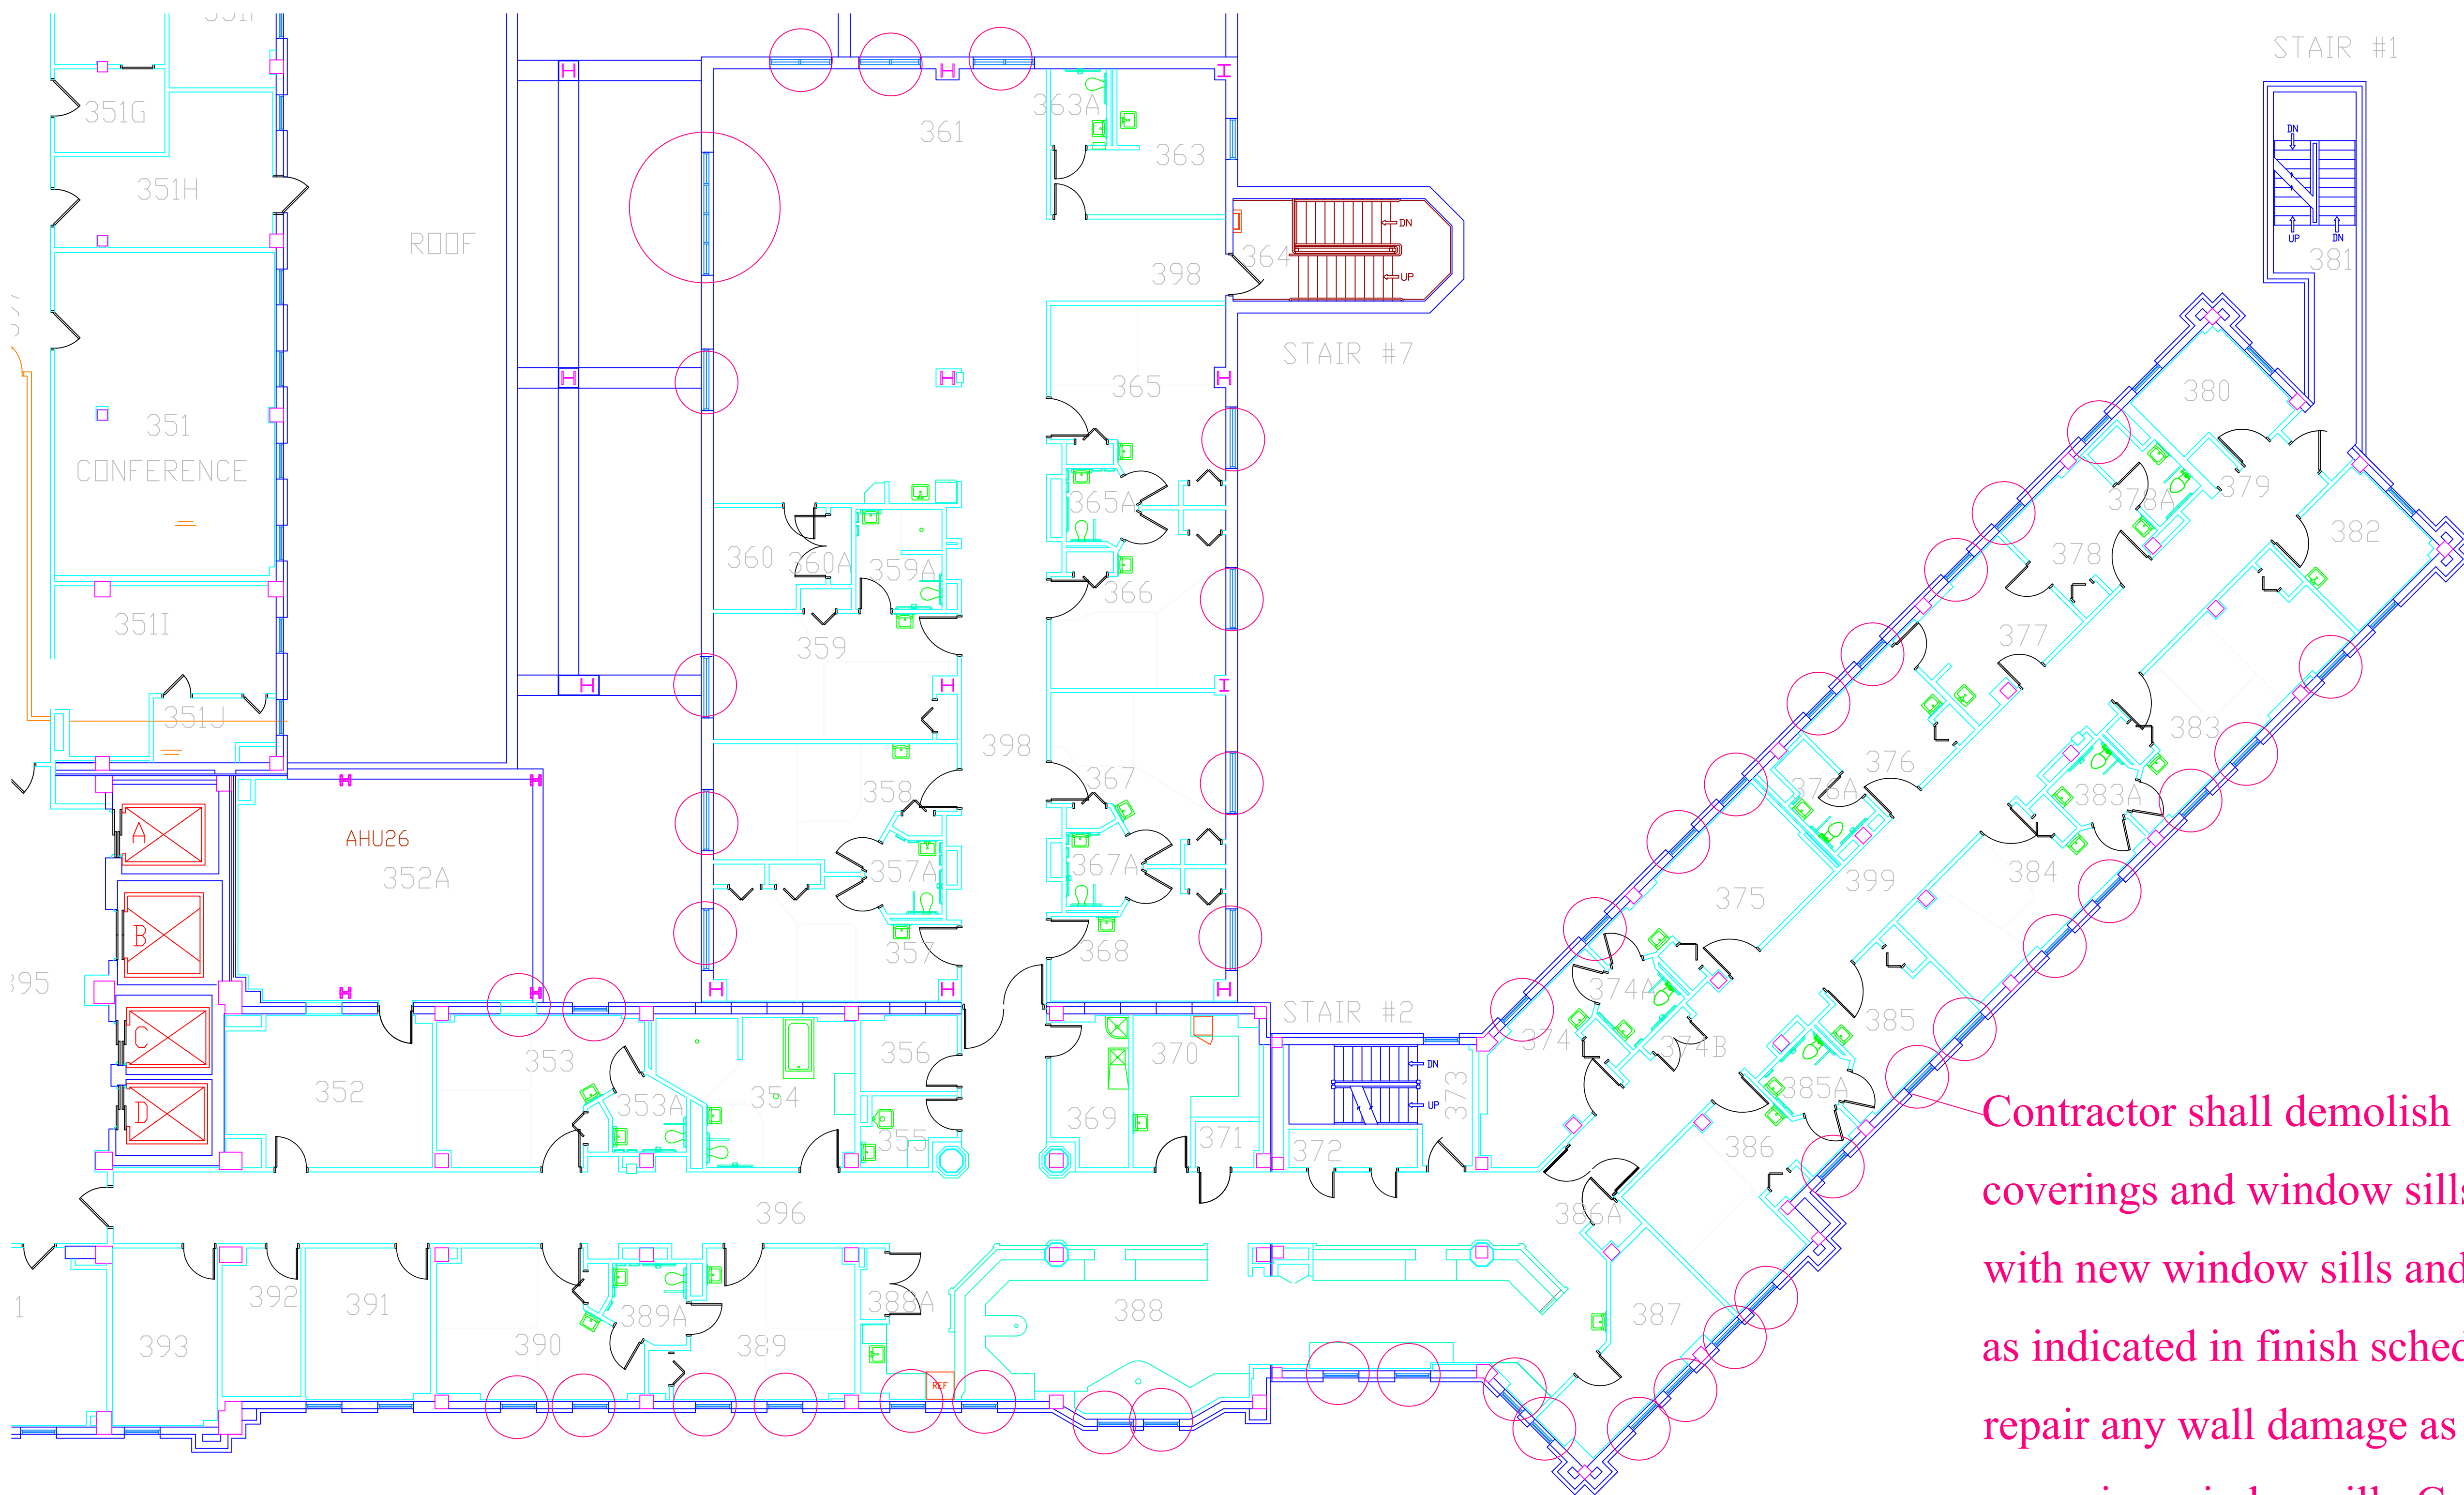
Contractor shall install wall protection on all corridor walls, inpatient room walls, and conference room walls as indicated on drawing. All walls outlined in yellow shall get wall protection 48" from floor. Contractor shall install 2" trim piece to cap off all wall protection

Contractor shall demolish all existing window coverings and window sills circled in pink and replace with new window sills and window coverings as indicated in finish schedule. Contractor to repair any wall damage as a result of removing window sill. Contractor is required to field verify all window covering and window sill measurements prior to ordering and installation.
